CITY OF FRANKLIN
PLAN COMMISSION MEETING*
FRANKLIN CITY HALL COUNCIL CHAMBERS
9229 W. LOOMIS ROAD, FRANKLIN, WISCONSIN
AGENDA
THURSDAY, MARCH 3, 2022, 7:00 P.M.

City of Franklin
Plan Commission Meeting
February 17, 2022
Minutes

CITY OF FRANKLIN
REPORT TO THE PLAN COMMISSION

FIGURE 40

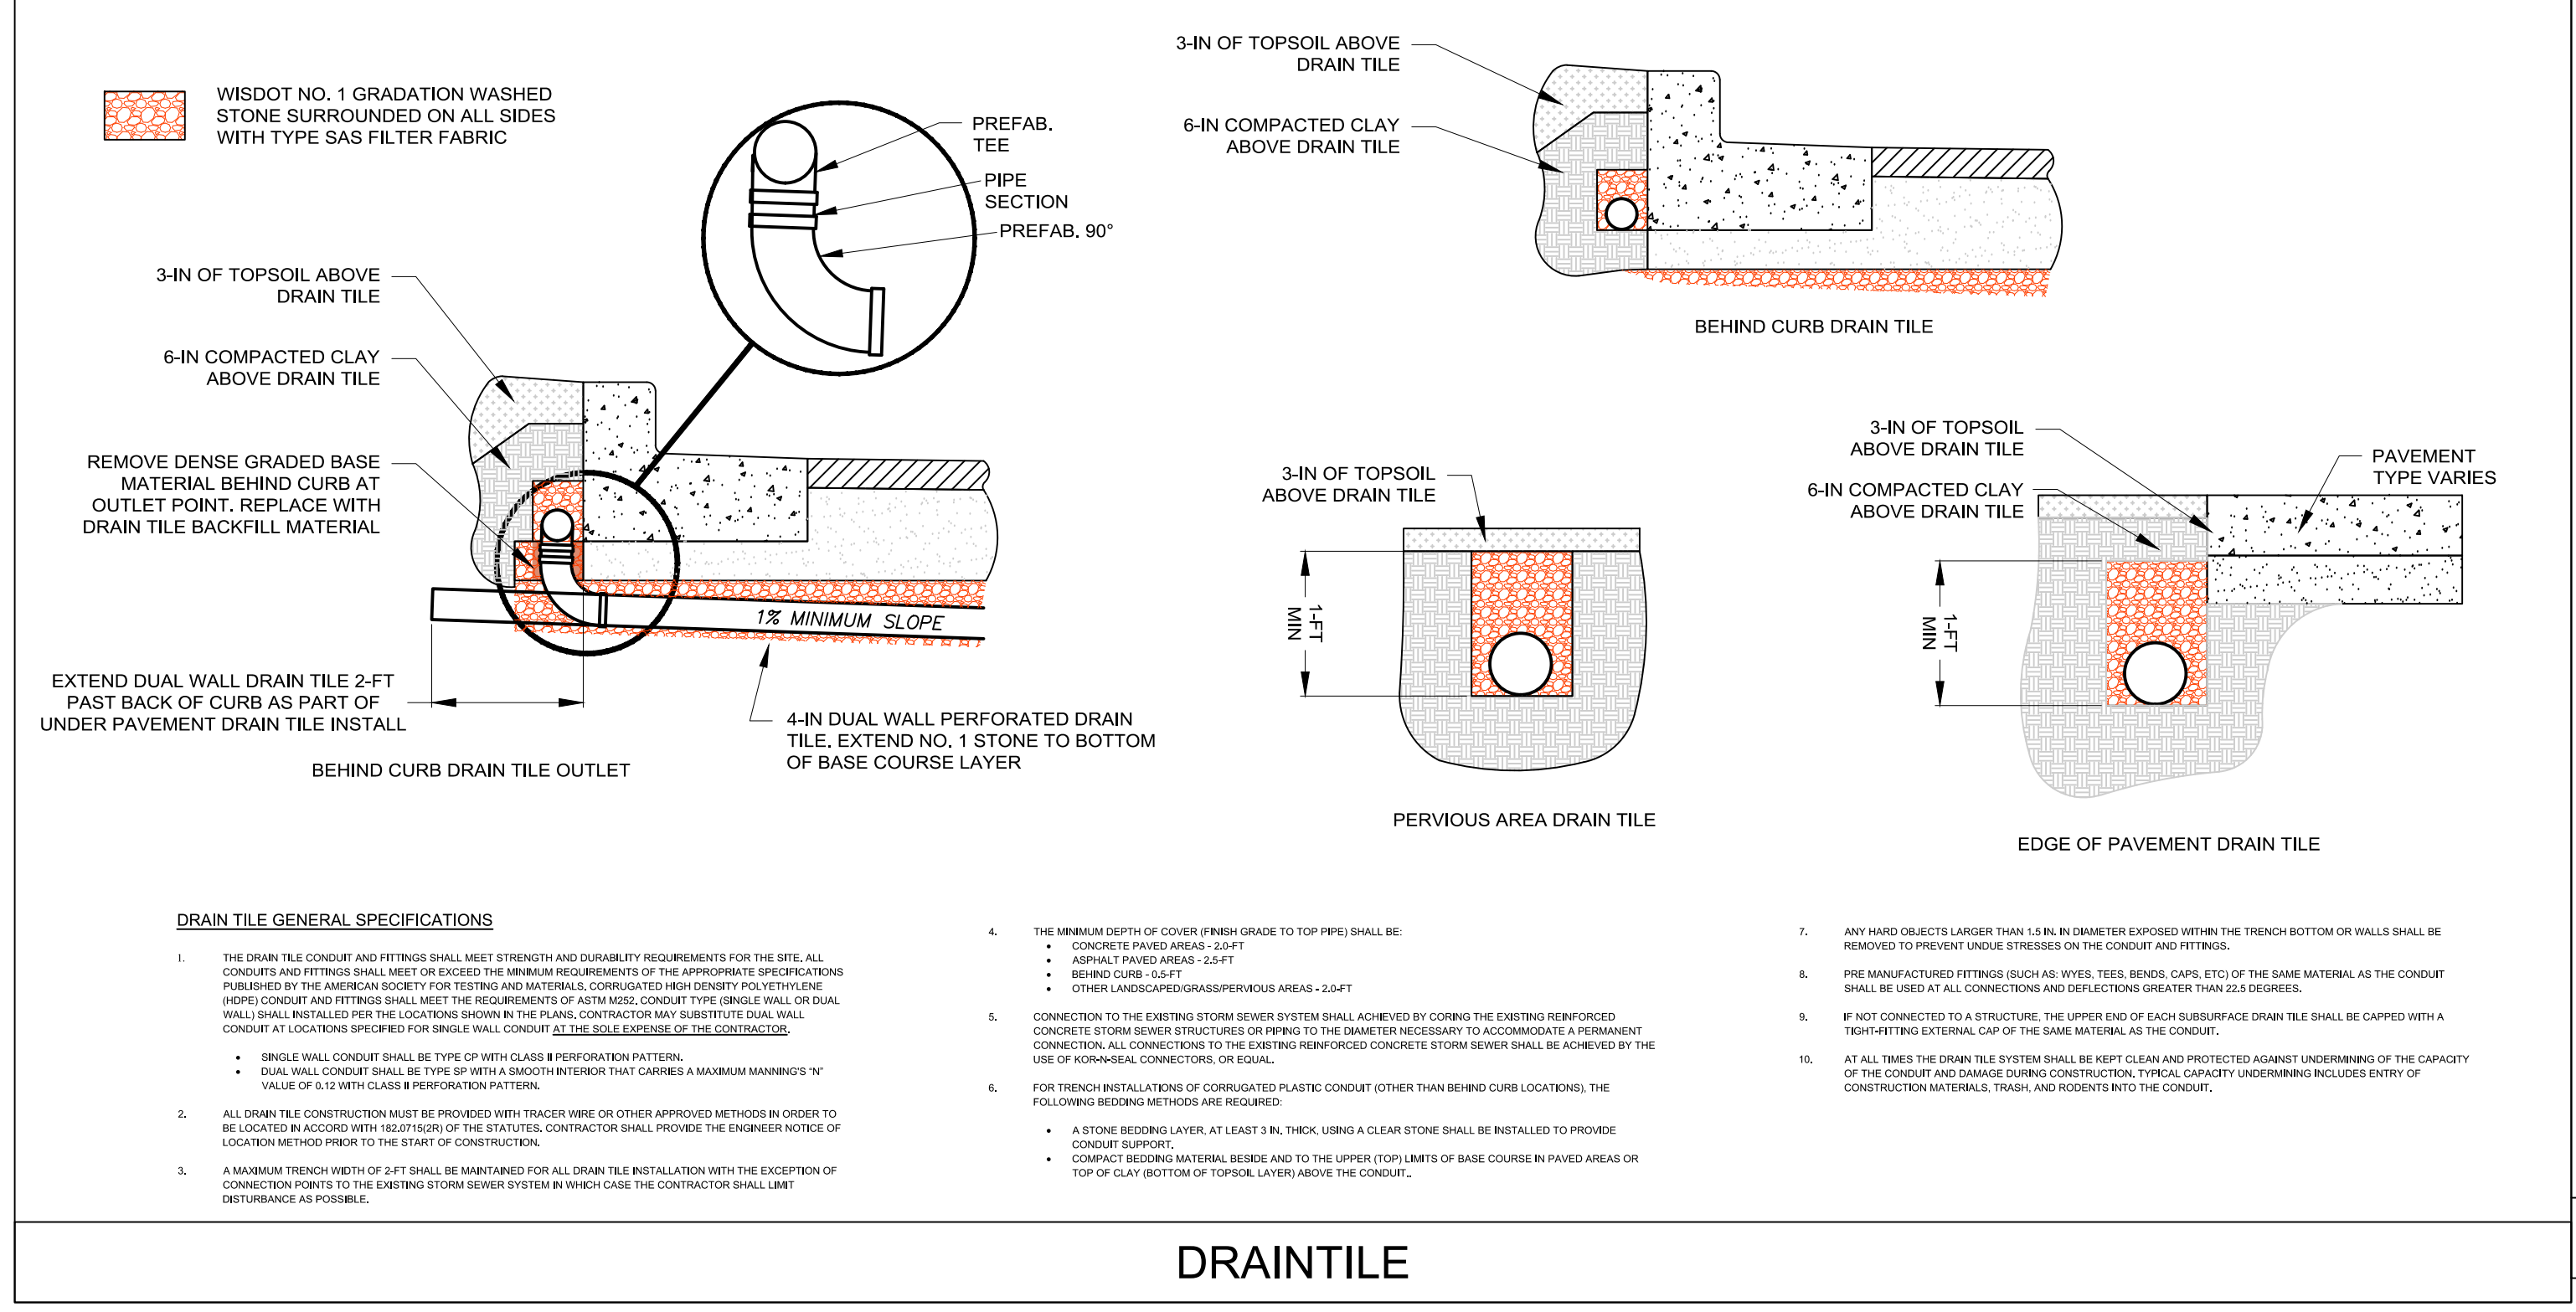
1. See Figure 40 of the [City of Franklin Design Standards and Specifications](#) for utilities vertical separation
 - a. 18-inch minimum for sanitary, 24-inch minimum for storm sewer
 - Removed PEG separation detail and added in City of Franklin detail
2. Bollards are okay around hydrants outside of ROW, but a minimum of 36-inches clearance around hydrants required
 - Added note to detail: minimum of 36-inches clearance around hydrants required

SDD 08D05-d: Curb Ramps Types 4B and 4B1

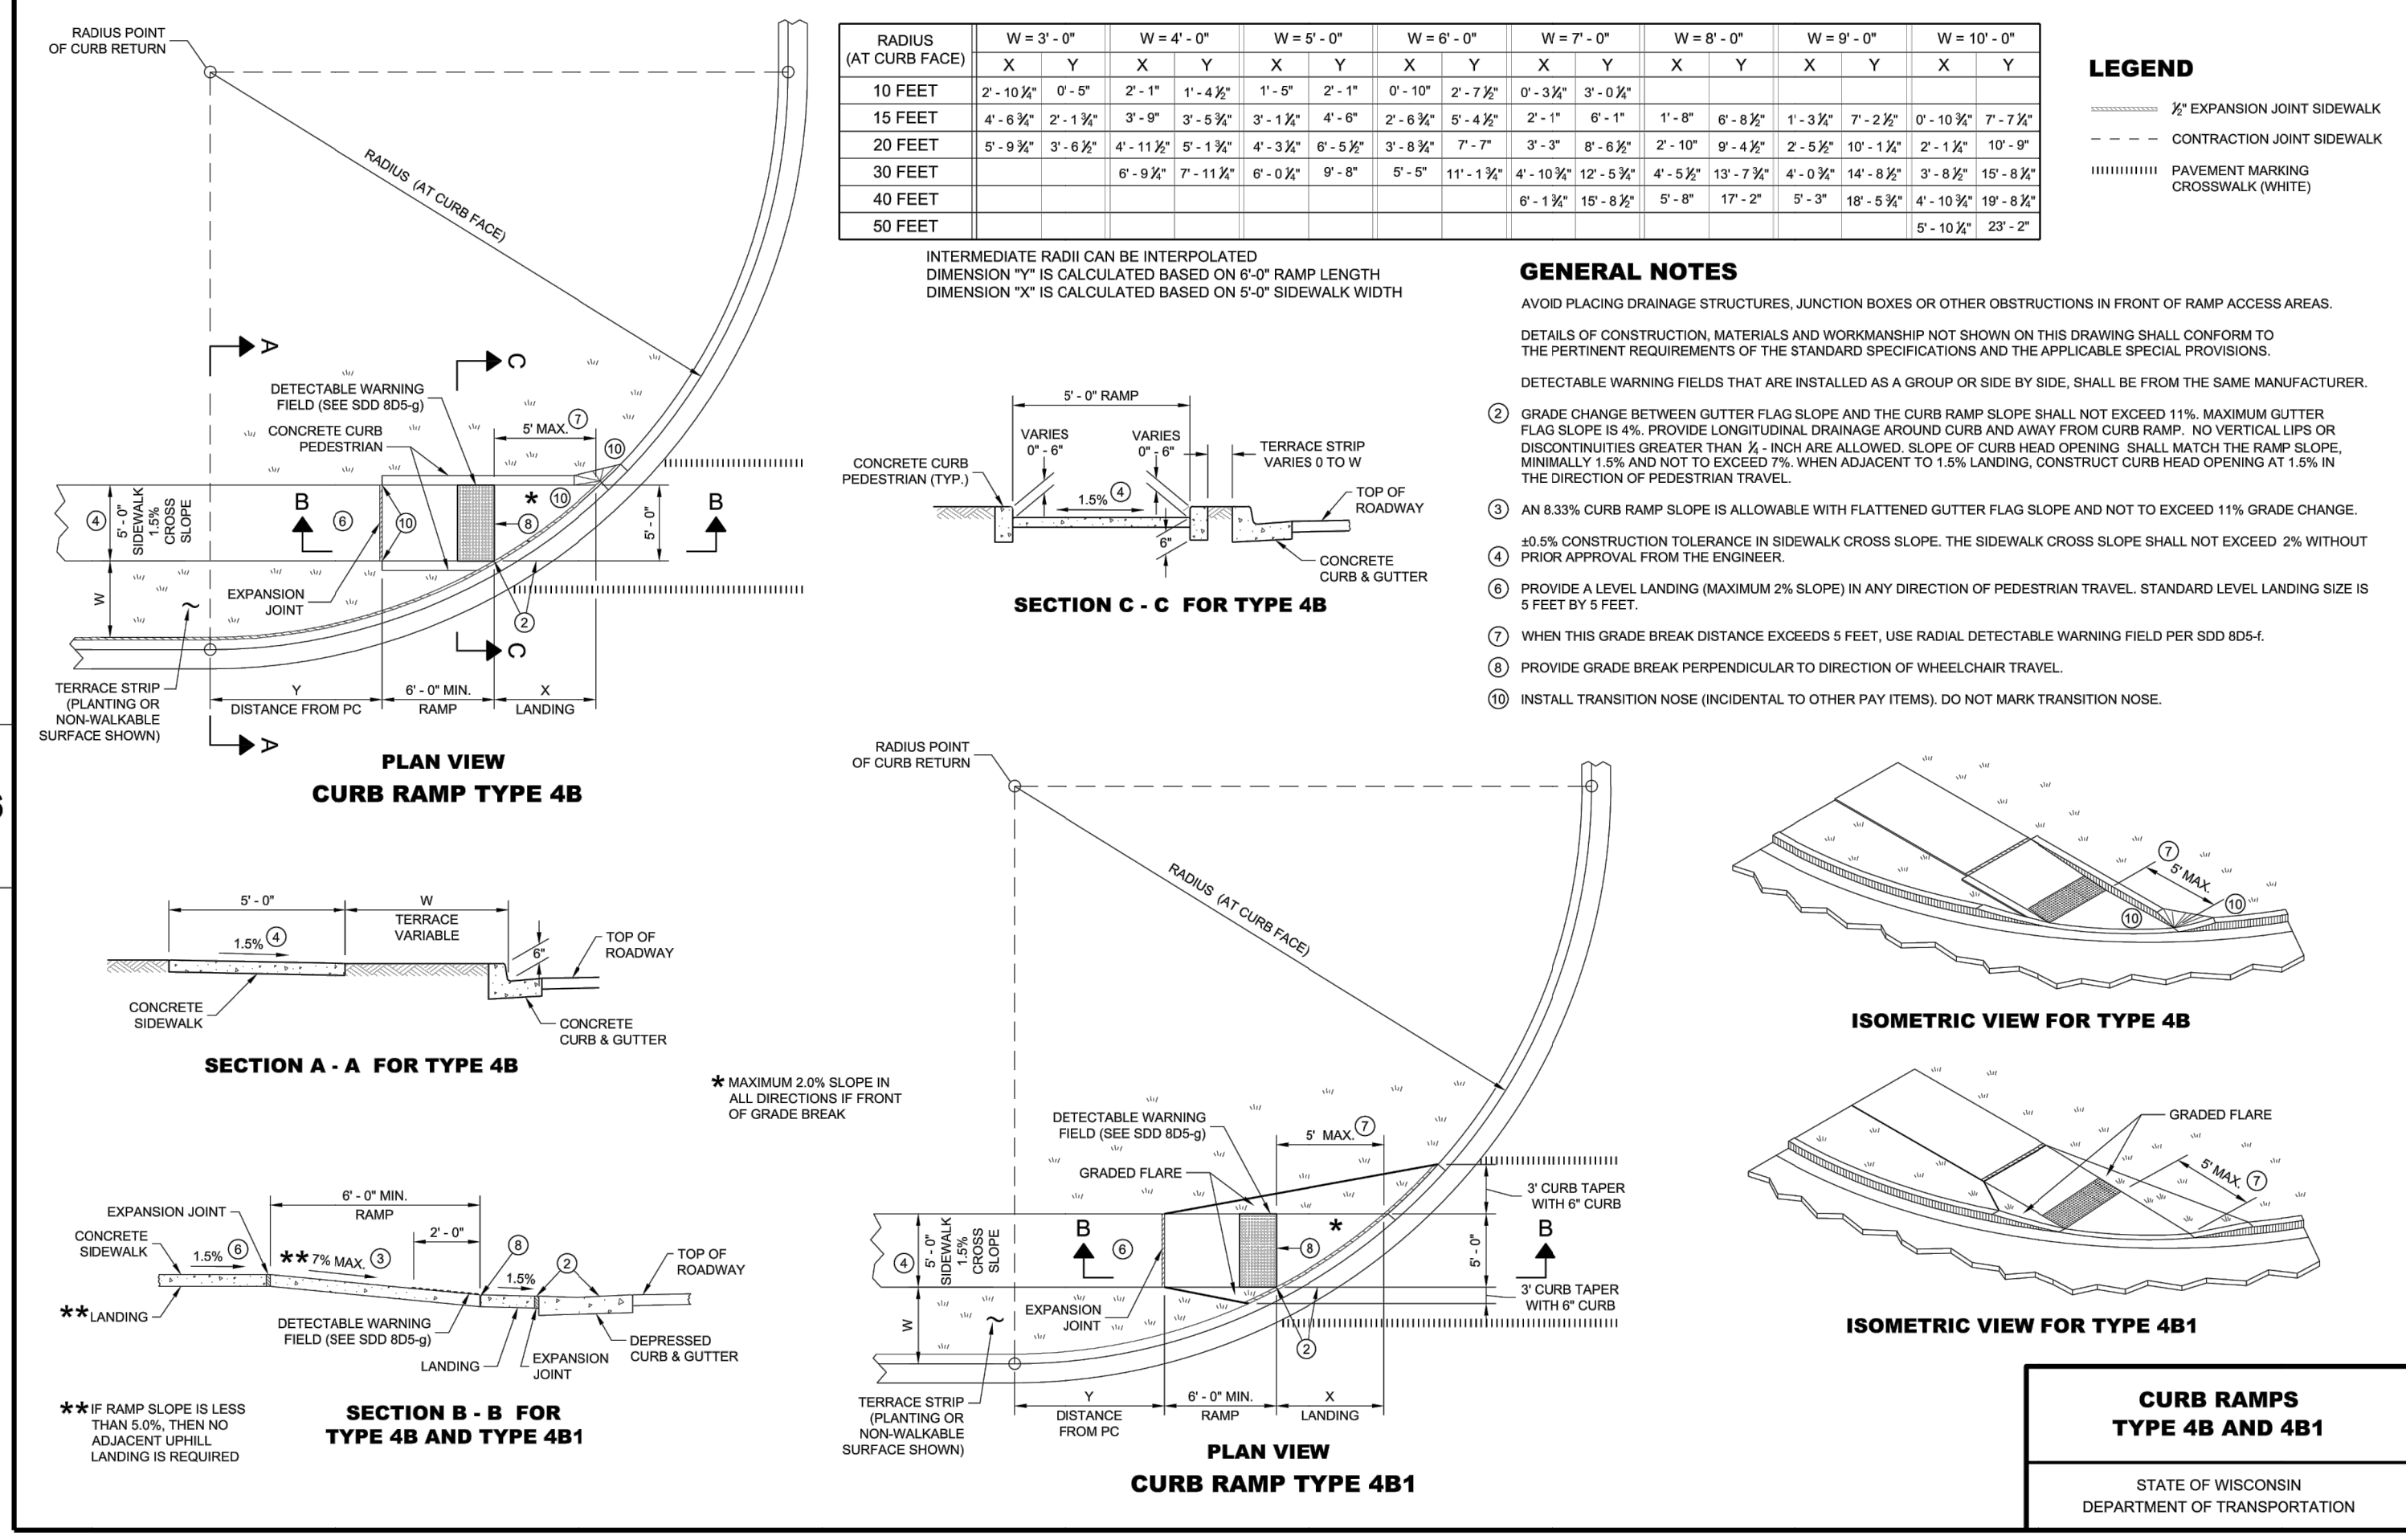
6. City curb ramp detail can be removed, curb ramps in ROW should follow WisDOT standard detail drawings
 - Removed city detail and added WISDOT SDD 08D05-d: curb ramps types 4B and 4B1 on Sheet C-22.
7. Note the 4-inch conduit required in Figure 15 for the driveways in City ROW
 - Added 4-inch conduit and called out on C-15
8. No reinforcement in sidewalk in City ROW
 - Added note to detail for no reinforcement within city R.O.W.
